UNITED STATES PATENT AND TRADEMARK OFFICE

10/809,138

Office Action Summary	Application No. 10/809,138	Applicant(s) GARNETT, PAUL JEFFREY	
	Examiner AARON R. EASTMAN	Art Unit 4147

DETAILED ACTION

Fig. 3A

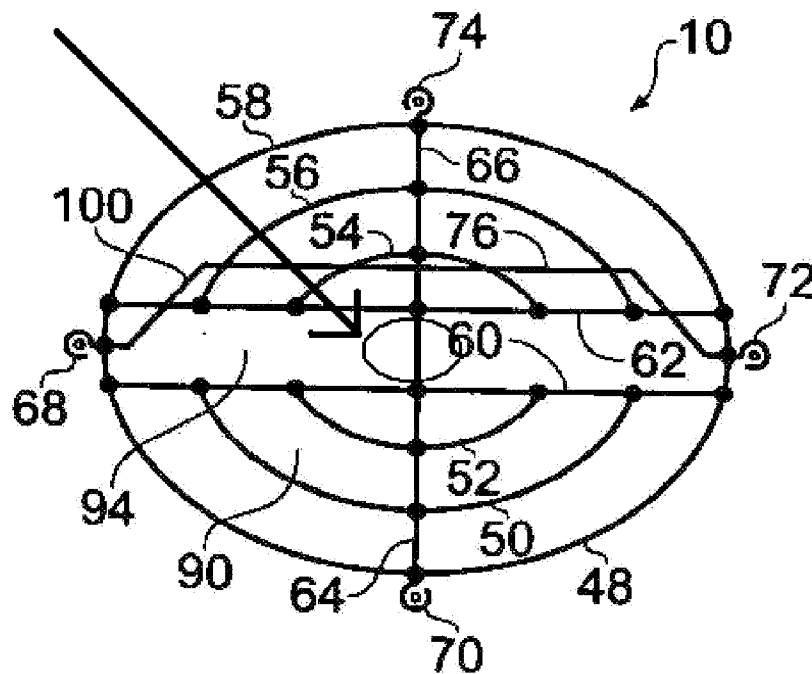
Please note that none of the figures show an opening configured to receive a handle as claimed. All of the figures with the exception of figures 4 and 5 show an obstruction (strut, loop or partial loop) that would prevent an opening from receiving a handle as claimed. It is noted in figures 4 and 5 that even though no obstruction is shown that an obstruction is part of the construction as evidenced by page 11, lines 12-15.

For the purposes of examination, only figure 3A of the instant application is considered. The examiner assumes that the portion of the strut circled above is shown in error since omission of this portion will allow similar grills to be stacked upon one another as claimed.

Figures 6 and 7 of US Patent Number 5,490,452 (Schlosser et al. hereinafter)

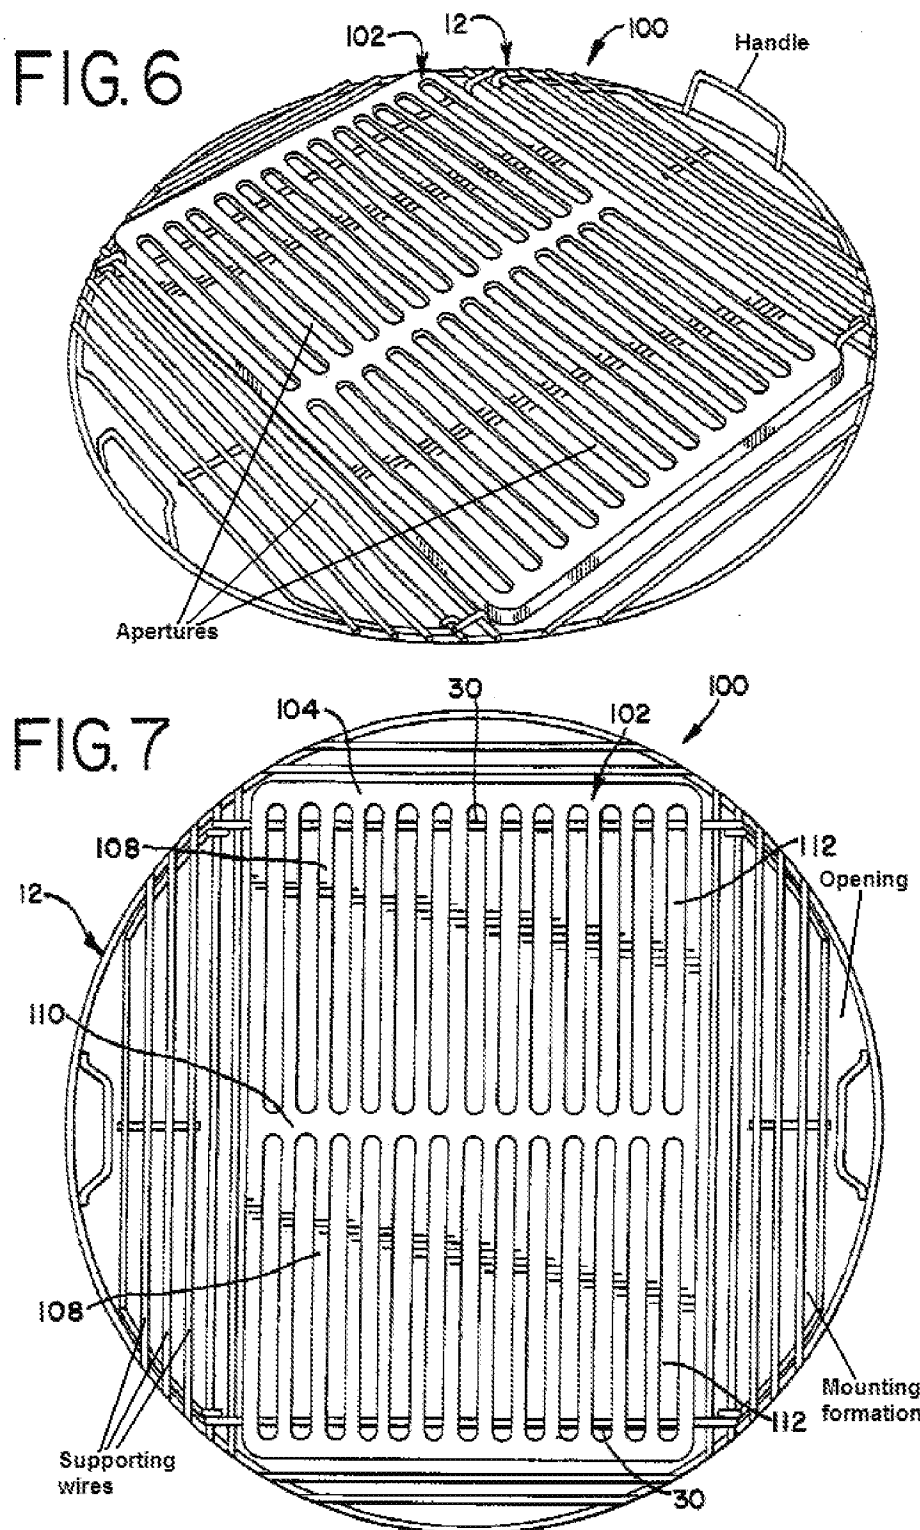
6. In re claim 1 Schlosser et al. discloses

A grill (100) capable of being mounted on a surface of a fan or fan housing, the grill (100) comprising:

a substantially planar portion; and

a handle extending out of the substantially planar portion so as to extend away from the surface of the fan or fan housing when the grill (100) is mounted thereon;

wherein the substantially planar portion of the grill (100) comprises an opening capable of receiving a handle of a substantially similar grill (100) when stacked on top of the substantially similar grill (100) such that the substantially planar portions of the stacked grills (100) are substantially parallel when the grills (100) are stacked;

wherein the opening is substantially coplanar with the substantially planar portion.

the grill of Claim 1, wherein said substantially planar portion comprises at least one shaped wire arranged to form a loop (12) or partial loop.

13. In re claim 18, Schlosser et al. discloses the grill of Claim 17, wherein the section of wire forming the handle portion extends away from said common plane, and wherein either end of that section wire is attached to said outermost loop (12).

Figure 1 of US Patent Number 5,822,186 (Bull et al. hereinafter)

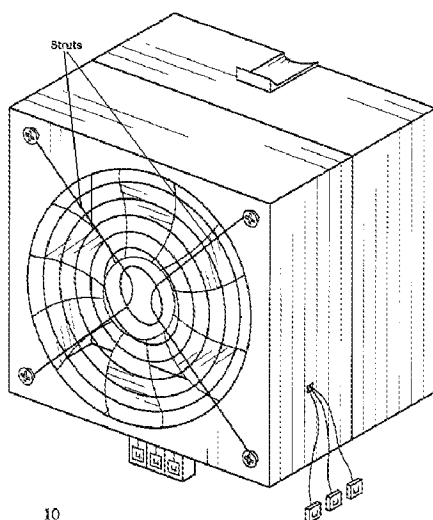
20. Bull et al. teaches a fan grill (18) comprising a substantially planar portion comprising a plurality of said loops or partial loops.

27. Bull et al. teaches at least one mounting formation (see Fig. 2 of Bull et al.) comprising shaped wire extending away from a substantially planar portion (18) and arranged to form a loop or partial loop (see Fig. 1 and Fig. 2 of Bull et al.).

30. Bull et al. teaches at least one mounting formation for mounting the grill on a fan or fan housing wherein at least one mounting formation and strut are integrally formed from a piece of shaped wire (see Fig. 1 and Fig. 2 of Bull et al.).

Figure 2 of Bull et al.

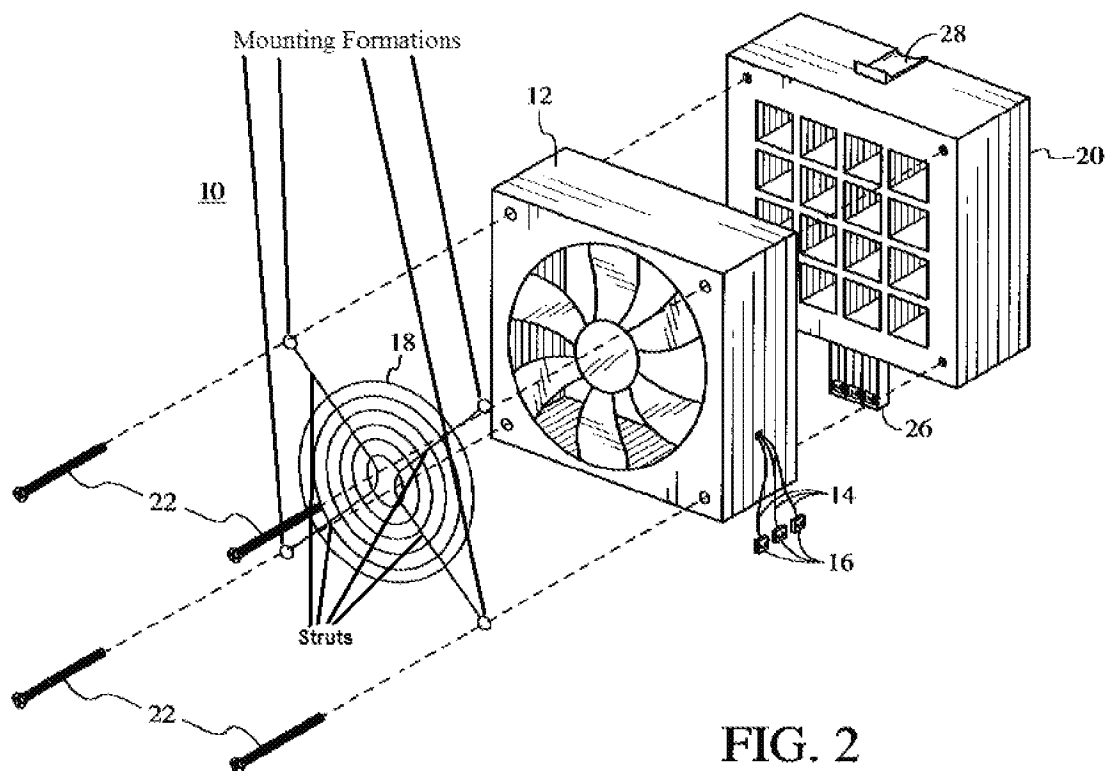
36. Bull et al. teaches wherein the section of wire shaped to provide support and at least one mounting formation are formed from a common section of wire (Fig. 2 of Bull et al.).

39. Bull et al. teaches further sections of wire shaped to form further loops or partial loops arranged in said common plane (Fig. 2 of Bull et al.).

42. Bull et al. teaches further sections of wire arranged to provide further support for the at least one loop or partial loop (Fig. 2 of Bull et al.).
